12 September 2018

Submission in Response to Proposed Pitt Street North Over Station Development (SSD 18_8875)

Figure 10: North-South Section showing proposed OSD and the NSW Masonic Club in blue

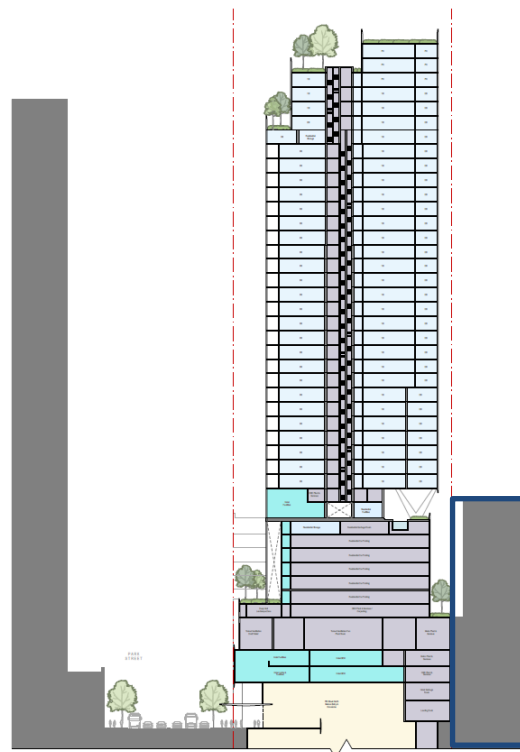
In the current proposal, there appears to be an attempt to provide some setbacks between the OSD and the NSW Masonic Club but at a higher level. This setback does not assist with improving light into the southern facing windows. The architectural plans provided indicate the proposed OSD will be built to the northern boundary up to the top of the NSW Masonic Club building when viewed from Castlereagh Street.

When examining the North-South Cross Section in more detail, Figure 11 below portrays our client's site as having a nil setback up to the fifth/top level of the proposed podium. It also does not show the corresponding uses of the floors of the NSW Masonic Club. As demonstrated in Figures 9 and 10 above, this is not the case as the setback extends down to the basement level of the building. Consequently, the section provided is inaccurate and does not present a true representation of how the proposed OSD interacts with the southern elevation of the NSW Masonic Club.

- Provision of a 7.6m building separation on the proposed ground level up to the podium terrace on level 12, consistent with the ADG design criteria. This should apply only to the central part of the building with a length of approximately 21m along the south facing windows.

Figure 11: Closer North-South Section showing inaccurate relationship between NSW Masonic Club

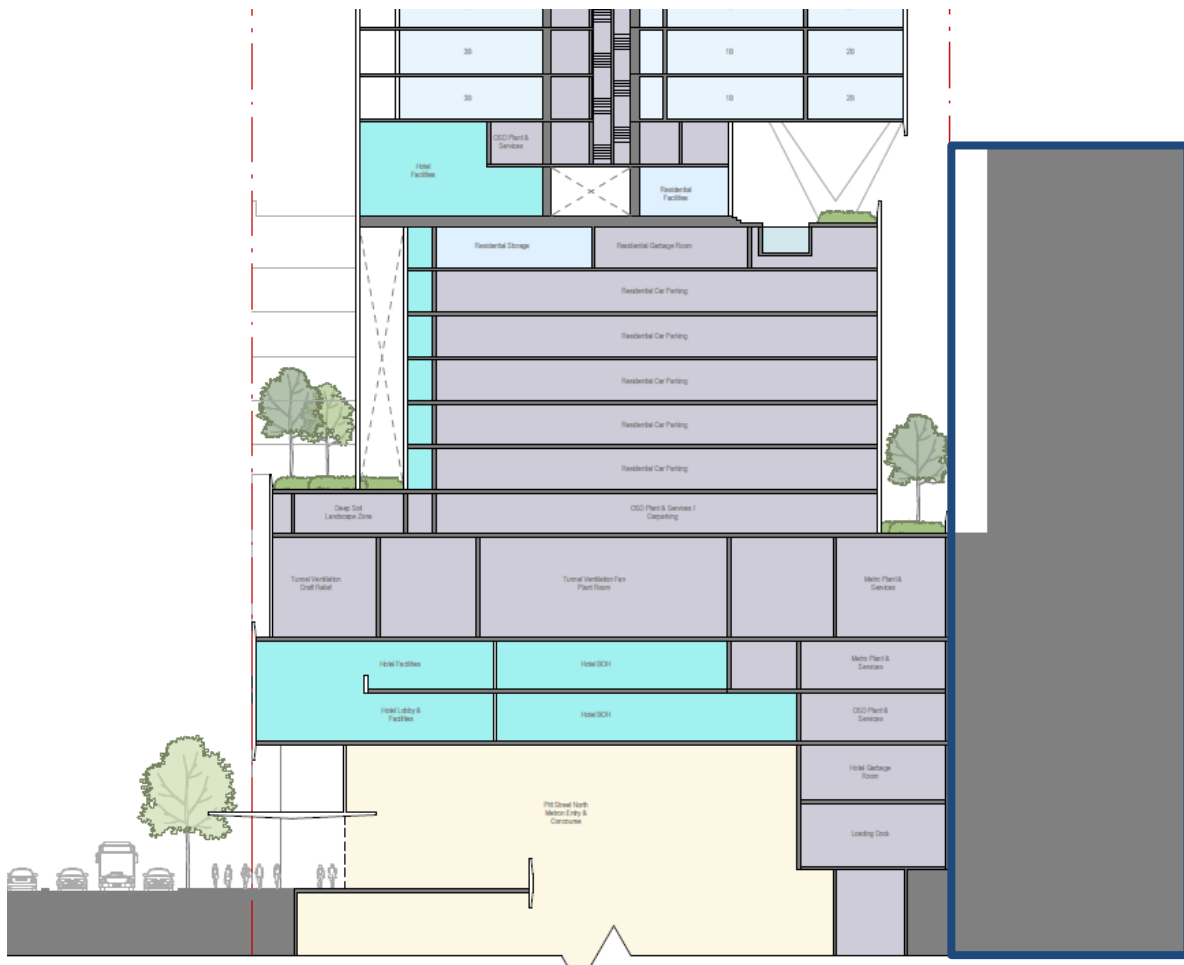
According to our measurements, the existing setback between the southern alcoves of the NSW Masonic Club and the southern boundary is approximately 1.6m. From windows associated with the hotel on levels 6 and above, the setback is approximately 2.6m. On the proposed level 5 of the OSD, there is an approximate 5m setback to the northern boundary. As such, there is a maximum building separation of approximately 7.6m between the two buildings.
